**BELL BEND NUCLEAR POWER PLANT
RESPONSE TO RAI No. 36
BNP-2009-385 Docket No. 52-039**

Response to NRC Request for Additional Information No. 36
Questions 08.02-1, 08.02-2, 08.02-3, 08.02-5, 08.02-6, 08.02-7 and 08.02-9
Bell Bend Nuclear Power Plant

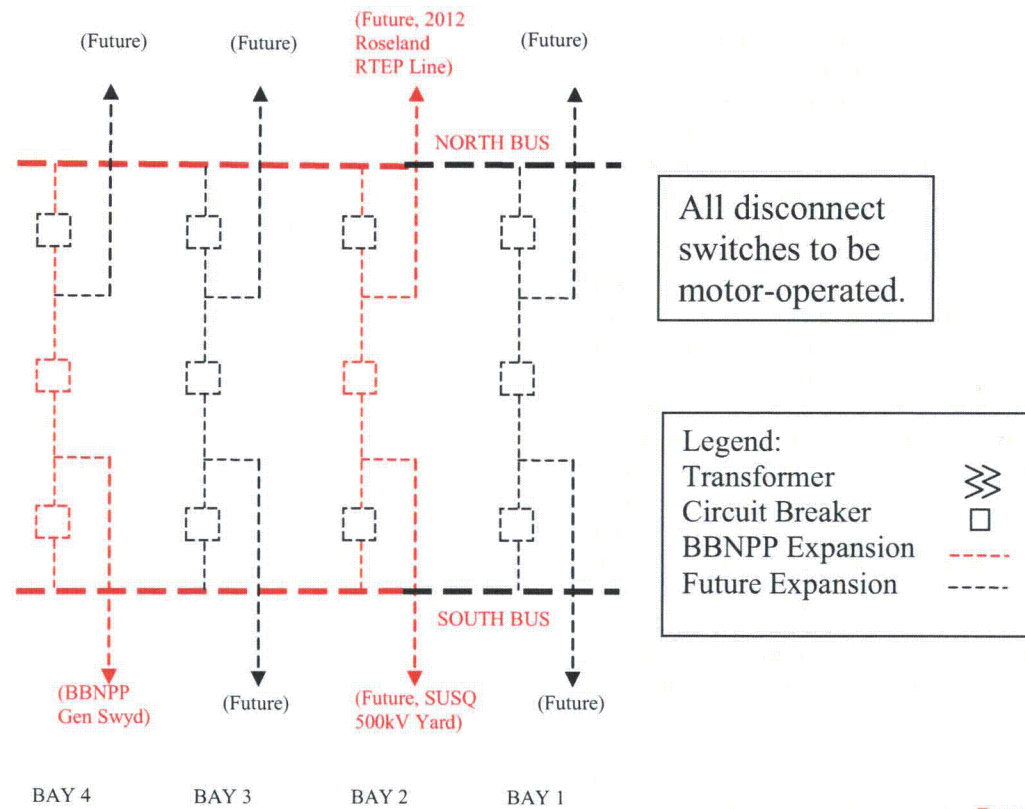
Bell Bend Nuclear Power Plant (BBNPP) 500 kV Switchyard Single Line Diagram shows only new Bell Bend NPP configuration but does not show the connection interface to the existing Susquehanna 500 kV switchyard and new Susquehanna 500 kV Yard 2. For the staff to better understand the planned configuration of the above-mentioned switchyards and transmission systems surrounding BBNPP, the FSAR should include within its scope any significant transmission lines for BBNPP. In order for the staff to obtain a better understanding of the function of the proposed design, as required to make a safety determination with respect to General Design Criterion (GDC) 17, please provide one-line diagrams of the proposed switchyards and transmission system for BBNPP showing interconnections and modifications to the existing switchyards. The single line needs to show the transmission line configuration as shown in Figure 8.2-1 Switchyard and Transmission Line Layout and as described in Section 8.2.2.4 indicating bay positions (e.g., identified as 2S, 2N, 7N, and 4s in Section 8.2.2.4) in these switchyards (i.e., existing 500 kV yard and new 500 kV Yard 2).

The requested drawings Susquehanna 500/230 kV Overview; Susquehanna 500 kV Yard; and Susquehanna 500 kV, Yard 2, are included, below.

BELL BEND NUCLEAR POWER PLANT
500KV GIS SWITCHYARD
TYPICAL MSU PLAN AND SECTION VIEWS

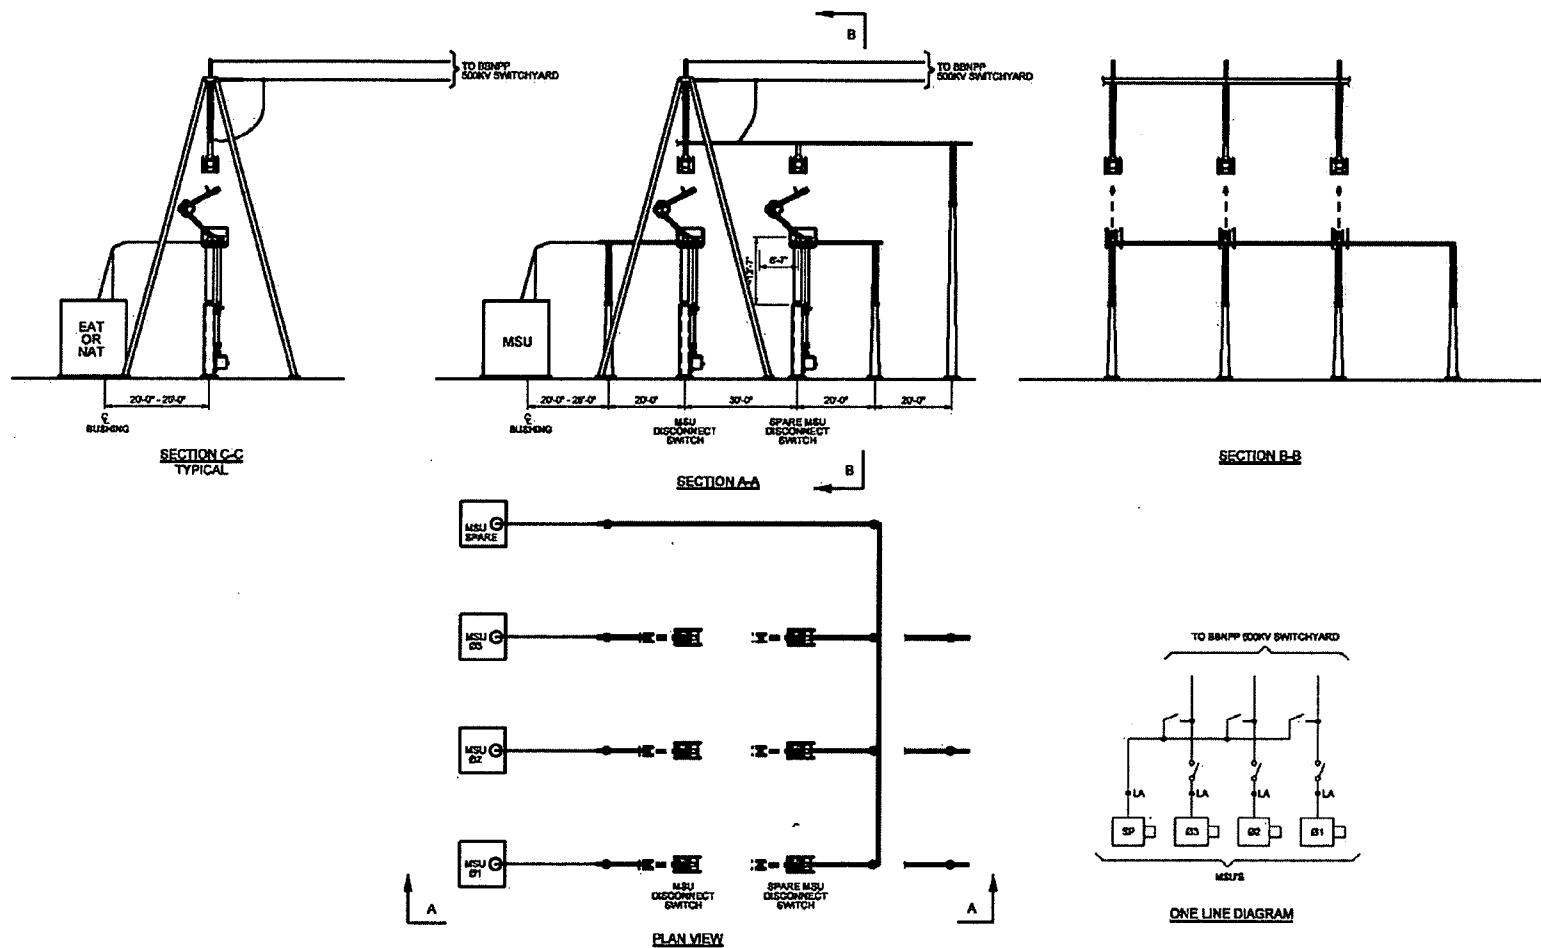
- a) Identify the standards (Institute of Electrical and Electronics Engineers (IEEE) etc.) that are being followed for the design, testing and installation of the GIS.
- b) Provide a description of the GIS components/equipment for the site-specific interconnection provisions between the GIS and the transformers (main step up transformer (MSU), emergency auxiliary transformer (EAT) & normal auxiliary transformer (NAT))
- c) Confirm that the insulation coordination for the switchyard has been performed to arrive at the basic impulse level (BIL) for the switchyard equipment. Provide summary results and assumptions.
- d) Provide the basis for selecting 40 kA as the interrupting rating of the 500 kV switchyard breakers.

- The 500 kV GIS will be located inside of the substation building. There will be a motor operated, SF₆ gas insulated disconnect switch (MOD) and a manually operated SF₆ gas insulated ground switch at the GIS associated with the MSU, each EAT, and each NAT. The purpose of each MOD is to isolate the gas insulated bus (GIB) and the purpose of each ground switch is to ground the GIB section when it is de-energized for maintenance. A GIB, one per phase, will be routed from the GIS located in the substation building, penetrating the wall of the substation building, to the location of a substation dead-end structure (Figure 1). The GIB will be supported on steel structures anchored to foundations. The GIB will terminate in an SF₆ to air bushing next to the substation dead-end structure. An open wire dropper will

- At the MSU, each EAT, and each NAT, an open wire dropper will connect each overhead line to its associated 500 kV motor operated disconnect switch and there will be an open wire connection from each disconnect switch to the 500 kV bushings of the MSU, EATs, and NATs, respectively. The purpose of each disconnect switch is to isolate the MSU, EATs, or NATs from the associated overhead line for maintenance of the line or the associated transformer. For the MSU, there will also be a 500 kV "sparing bus" with associated 500 kV motor operated disconnect switches. The purpose of the "sparing bus" is to facilitate the switching-in of the single phase spare MSU to replace one of the failed single phase MSU transformers.

- Figure 1 is a plan view of the substation building containing the GIS and shows the location of the substation dead-end structures connecting overhead lines from the MSU, EATs, and NATs. BBNPP FSAR Figure 8.2-1 shows the overall general arrangement of the plant site including the conceptual routing of the overhead lines between the GIS and the MSU, EATs, and NATs. A plan view and typical section views of the connections are shown on Figure 2 as Sections "A-A" and "B-B" for the MSU, and Section "C-C" for the EATs, or NATs.
